DeKalb County Historic Preservation Commission

Staff Report

E. 1320 Harvard Road, David Price. Modify a previously approved COA to renovate accessory structure, construct a garage, and modify driveway. **1247660**

BIRNBAUM/KLEIN RES.
1320 HARVARD ROAD
ATLANTA, GEORGIA
PROPOSED ADU
PLANS & ELEVATIONS
SHEET A-1
JUNE 23, 2025

FRONT ELEVATION
SCALE: 1/4" = 1'-0"

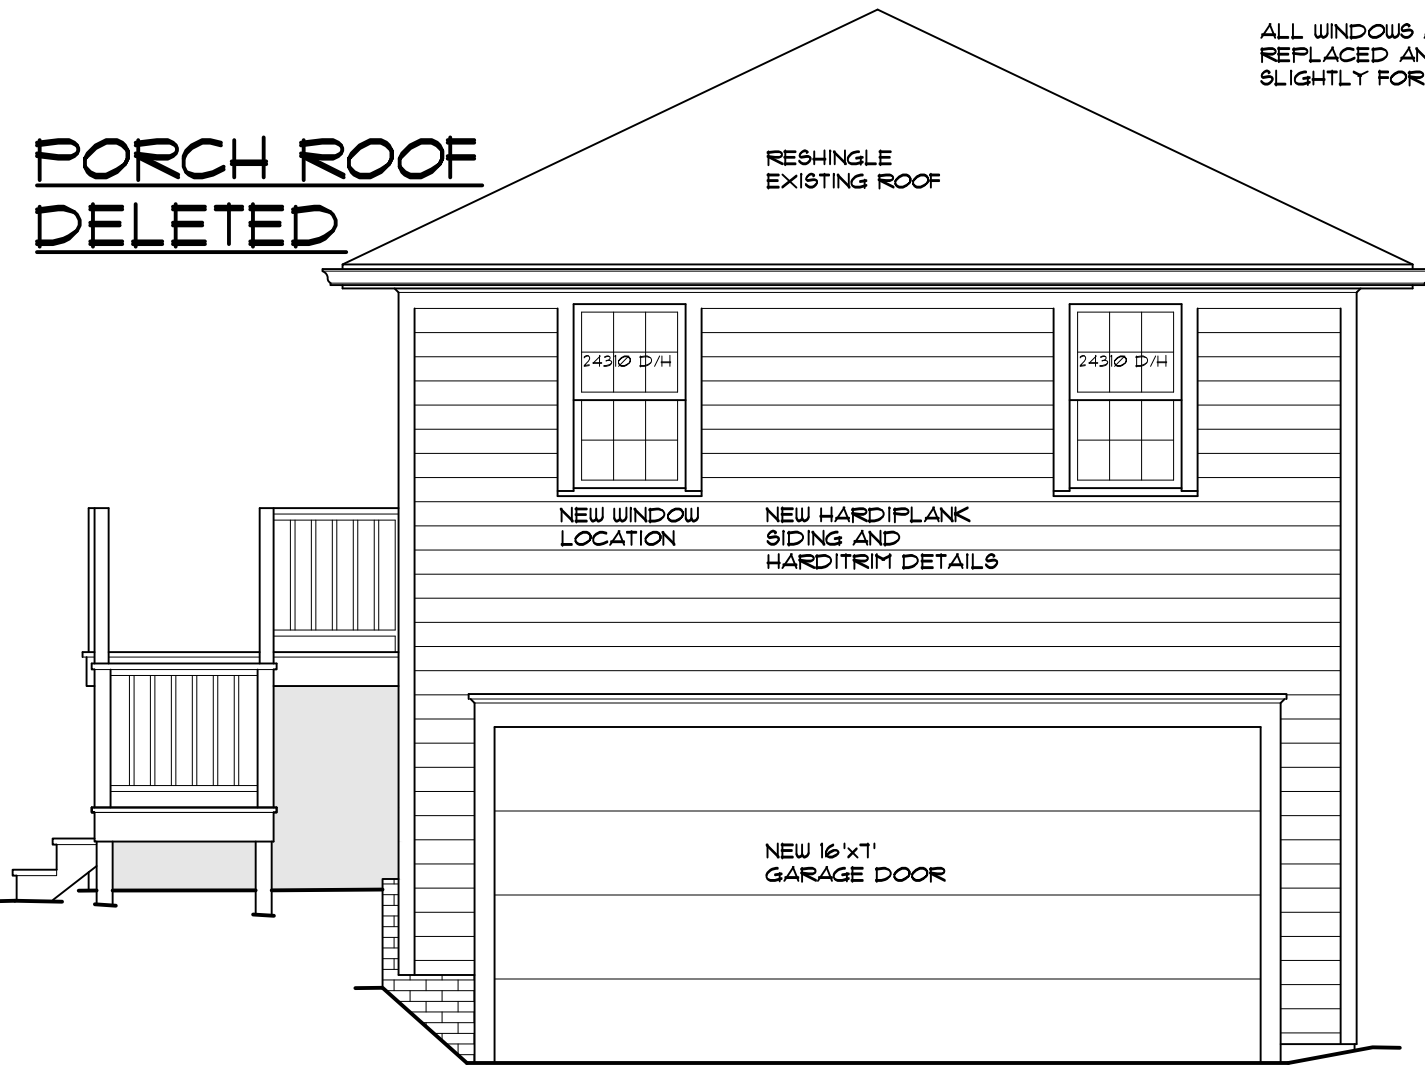
PORCH ROOF
DELETED

APPROVED NEW PORCH ROOF DELETED DUE
TO FORCED LOT COVERAGE REDUCTION
BELOW THE EXISTING HISTORIC 43.25% AMOUNT
TO 41% LOT COVERAGE PER ZBOA DECISION
